Access Compliance Report Public Rights-of-Way (Curb Ramps)

Main Street: N/A Cross Street: ANDAZA_ST Location: N

ADA ID: RPRK211129140744 Ramp Type: Type 4 - Parallel Initial Pass/Fail: Pass Overall Compliance: No Severity Score: 5

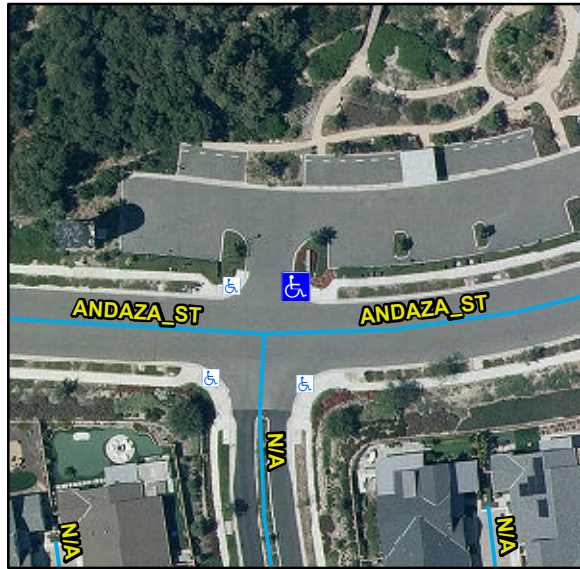
Compliance	Description	Data	Compliance	Description	Data
N/A	Ramp Length LT (in)	99	N/A	Ramp Length RT (in)	108
Yes	Ramp Width LT (in)	60	Yes	Ramp Width RT (in)	60
Yes	Ramp Run Slope LT (%)	7.7	Yes	Ramp Run Slope RT (%)	2.1
Yes	Ramp Cross Slope LT (%)	1.6	Yes	Ramp Cross Slope RT (%)	0.3
N/A	Landing Present	Yes	Yes	DWS Provided	Yes
N/A	Landing Length (in)	60	Yes	DWS Contrast	Yes
Yes	Landing Width (in)	48	Yes	DWS Length (in)	36
Yes	Landing Run Slope (%)	0.3	Yes	DWS Full Width	Yes
Yes	Landing Cross Slope (%)	1.1		DWS Offset Type	Single
N/A	Landing Movement Obstructed?	No	Yes	DWS Offset Left (in)	0
	Landing Movement Type	Curb	Yes	DWS Offset Right (in)	N/A
N/A	Landing Shared	No			
N/A	Clear Space	Yes			
N/A	Clear Space To Crosswalk (in)	48			
N/A	Marked Crosswalk 1	No	N/A	Marked Crosswalk 2	No
	Crossing 1 Direction	W		Crossing 2 Direction	S
N/A	Marked Crosswalk 1 Width (in)	N/A		Marked Crosswalk 2 Width (in)	N/A

N/A	Ramp Inside Crosswalk 1	N/A	N/A	Ramp Inside Crosswalk 2	N/A
	Crossing 1 Slope (%)	8.4		Crossing 2 Slope (%)	5
	Crossing 1 Cross Slope (%)	1		Crossing 2 Cross Slope (%)	1.8
Yes	Gutter Ponding	No	Yes	Curb Slope	5.7
Yes	Gutter Lip Height (in)	0		Road Run Slope (%)	0
No	Gutter Run Slope (%)	5.7		Road Cross Slope (%)	1
Yes	Gutter Cross Slope (%)	1.1	Yes	Perpendicular Joint Present	Yes
Yes	Overall Surface Condition	Acceptable			
	Cross Gutter Present?	No		Spandrel Present?	No
	Replace Cross Gutter?	N/A		Replace Spandrel?	N/A

Possible Solutions:

Remove & Replace Gutter.

R304.5.4, STD 1115
